PROJECT:
LOWER FALINGE

DESCRIPTION:
Elevations as Proposed - Pershore Ph4

PURPOSE OF ISSUE:			
Planning			
DRAWN BY:	CHECKED	DATE:	SCALE @ A1:
AP	VS	30/06/23	As indicated
JOB NO:	STATUS CODE:	DRAWING NO:	REV
3749	S2	109	1
FILE IDENTIFIER:			
LF-BTP-00-E-DR-A-3749_109.1

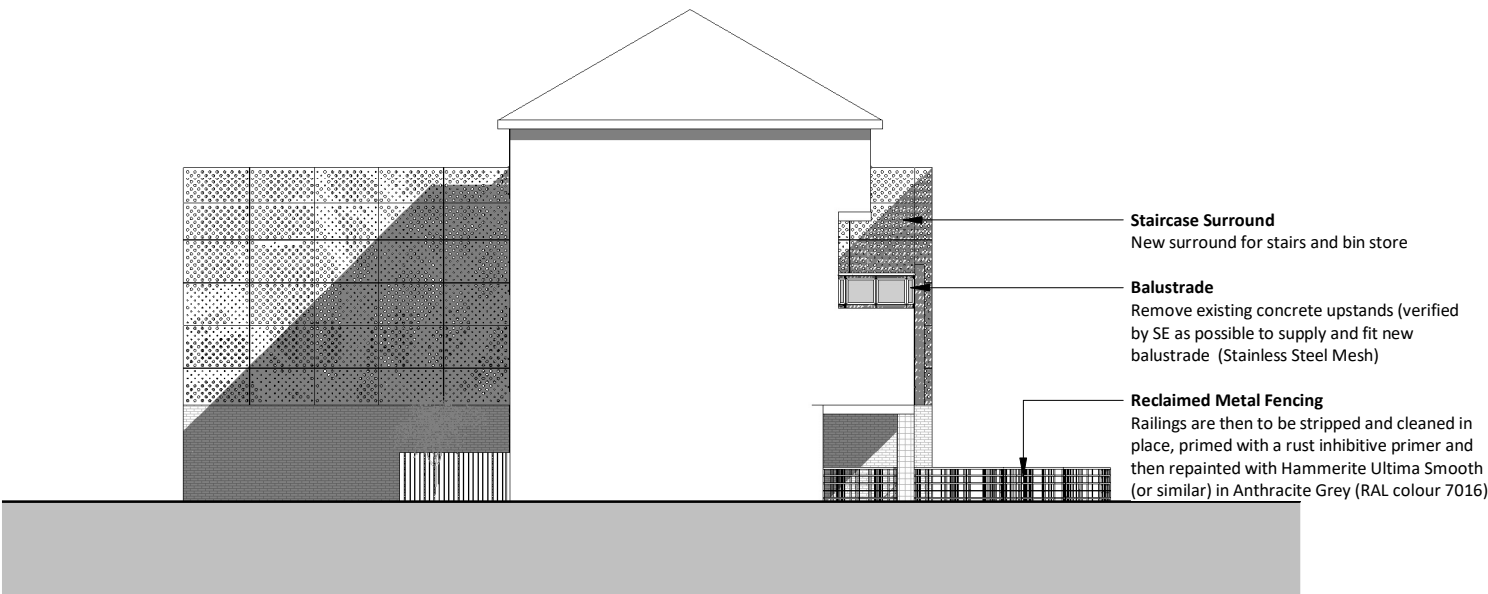
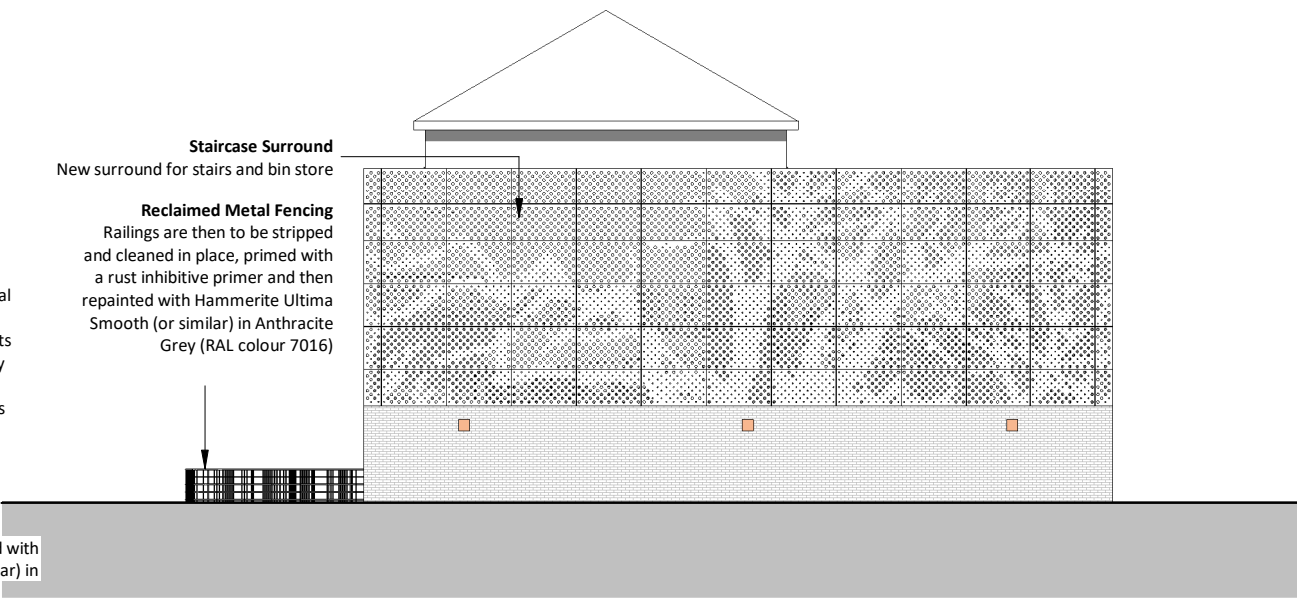
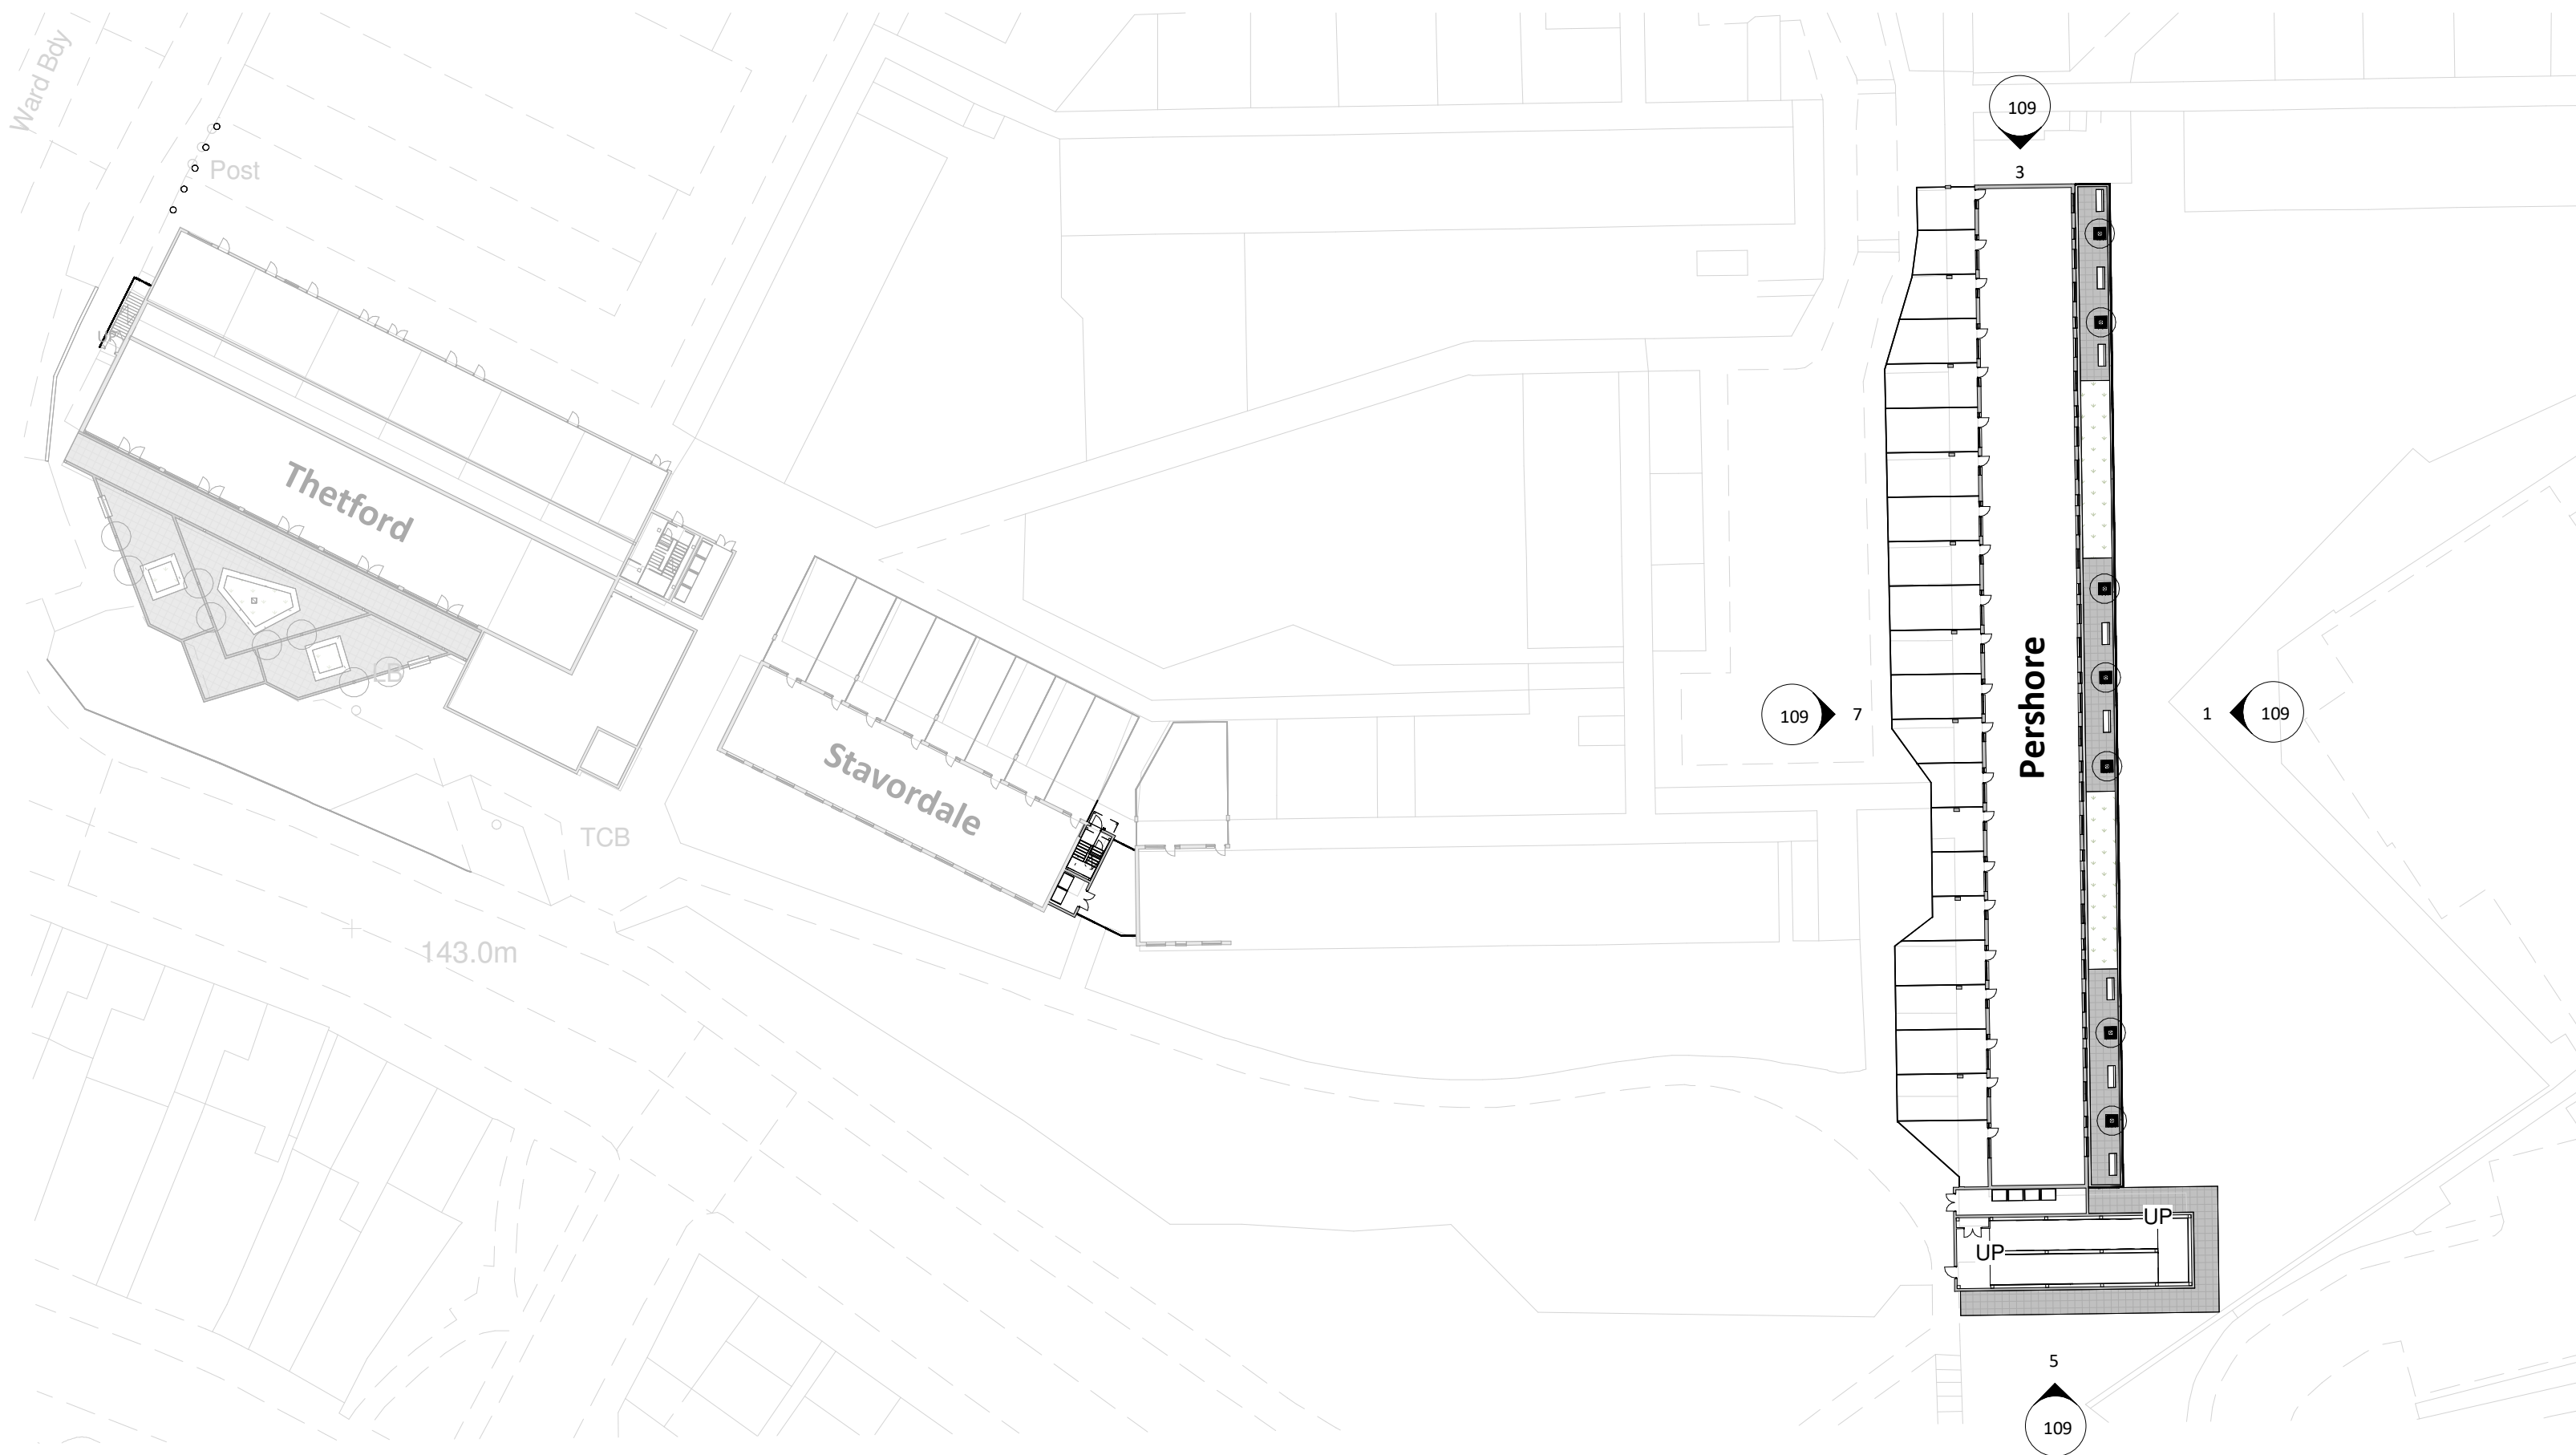
1	19.10.22	AP	Drawing revised to increase the height of the proposed perforated aluminium panel system following Contractor's comments.
Rev	Date	Int	Description
